Certificate of Appropriateness

2624 N. Grant Boulevard, Grant Boulevard Historic District

Replace existing wood fence with 4' solid wood fence with upper 2' 50% open per the attached design.

Date issued 1/23/2025

Fence design

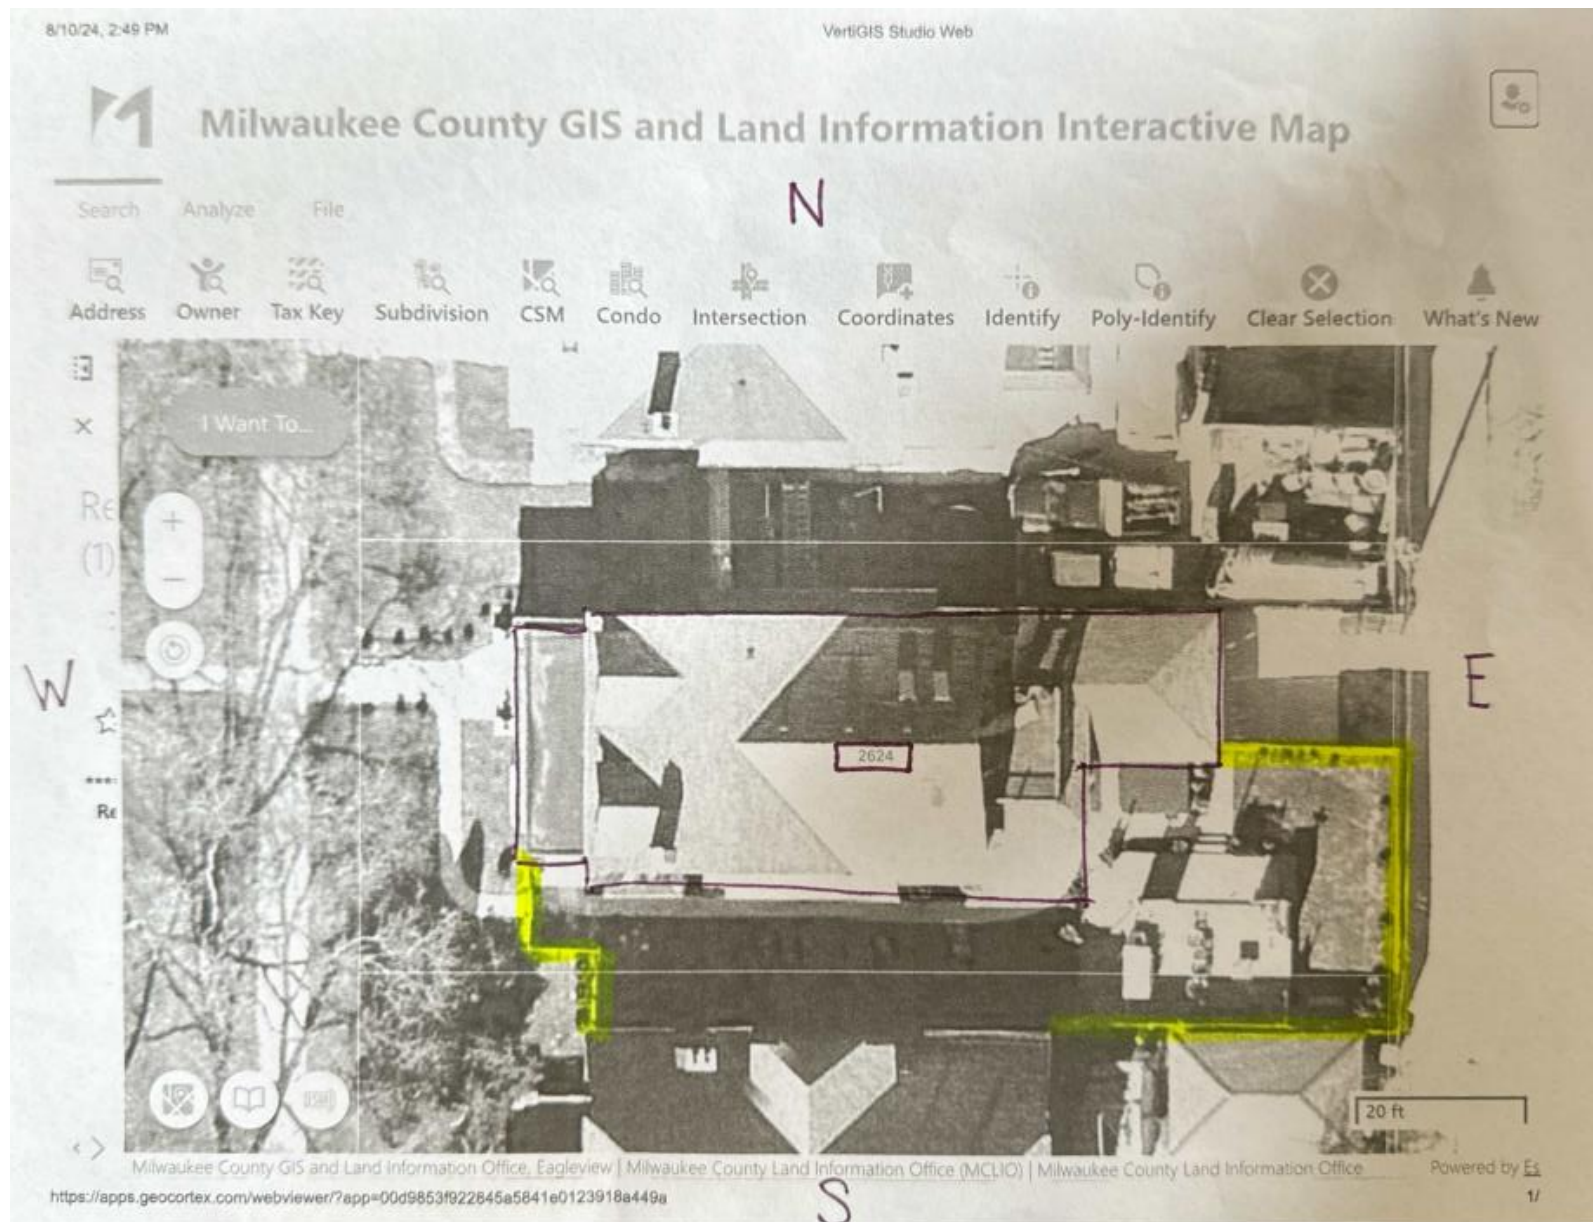
Fence location. Note: this COA applies to the fence on 2624 N. Grant Blvd. only. An additional COA will be issued for the portion of the fence that is on 2616 N. Grant Blvd.
